Power Section

Battery Charging Section

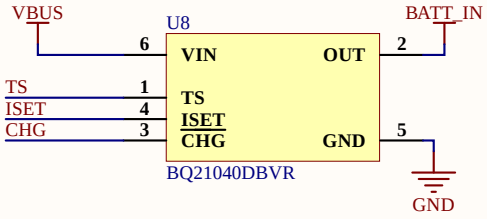
Place Decoupling Capacitor with there respective pins.

ISET Resistor Value is changed in Parameters, please be careful.

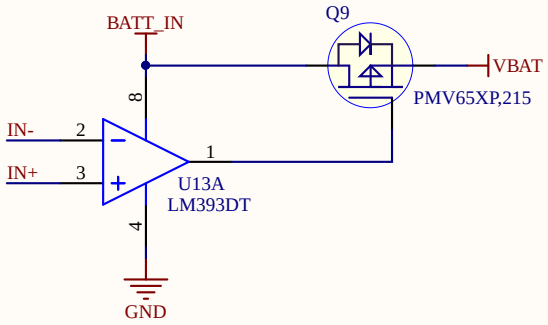
As per Datasheet, the value should not exceed 675 Ohm.

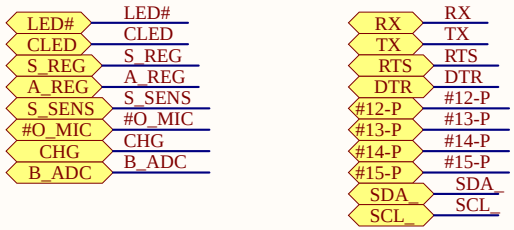
External Enable wouldn't be used as Development board already had circuit.

Controller Section

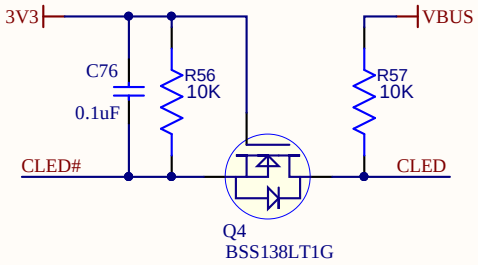
SW2 is being used for Software Reset.

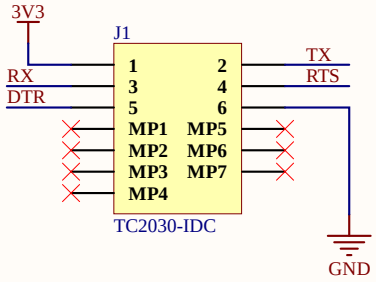
Mentioned Capacitors will be placed with Battery Connector and with USB Main Connector.

No Need to place Decoupling Capacitors with Switch as this is just path.
